華埠分區規劃草案的公眾回饋

波士頓規劃局於2024年11月19日發佈了華埠分區修正案草案、分區地圖草案和設計指南草案；公眾評論期至2025年2月5日。在整個公眾評論期內，規劃局工作人員透過各種形式徵求回饋意見，包括調查、電子郵件、意見函和請願書。

圖1 2010年以來Longwood地區原機構用地情況

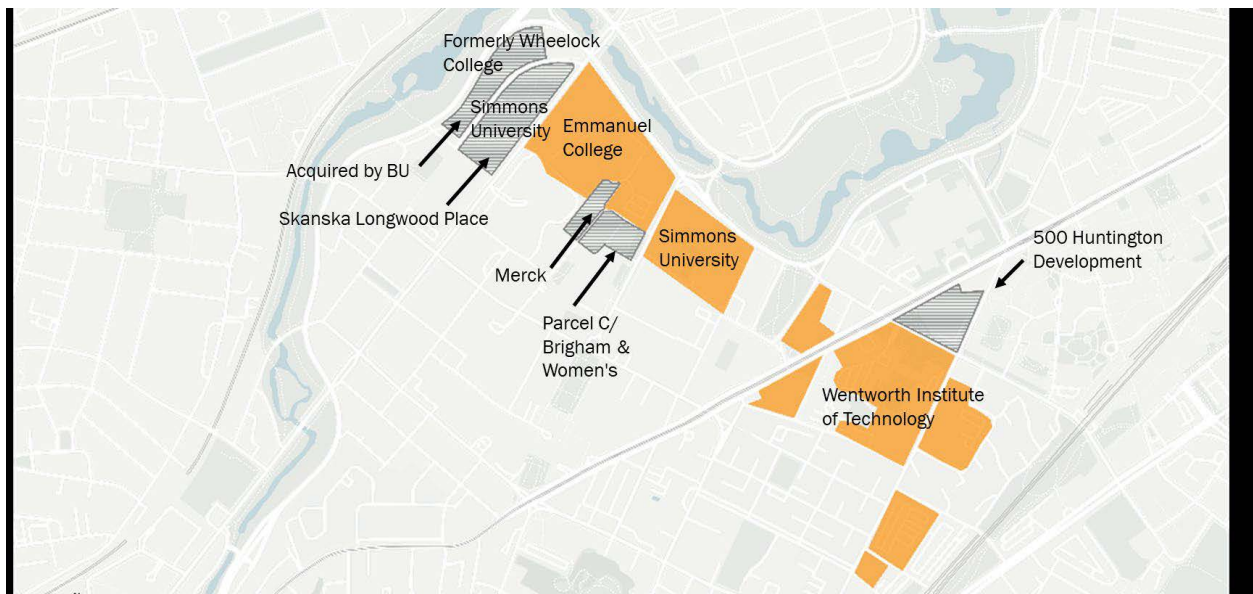
- **Longwood的「分區屬性變更」(De-accessioning)**一直透過IMP管理，並增添了相容用途。在Longwood地區，從IMP劃出的土地，其用途通常從教育用途轉變為支持Longwood地區的研究、生命科學及臨床需求的用途。以下附有一張地圖。隨著Simmons Residential Campus重新開發為辦公、生命科學及住宅用途，預計這一趨勢還將繼續。

這凸顯了Longwood地區的任何重新分區中，將研究實驗室列為允許用途的重要性。
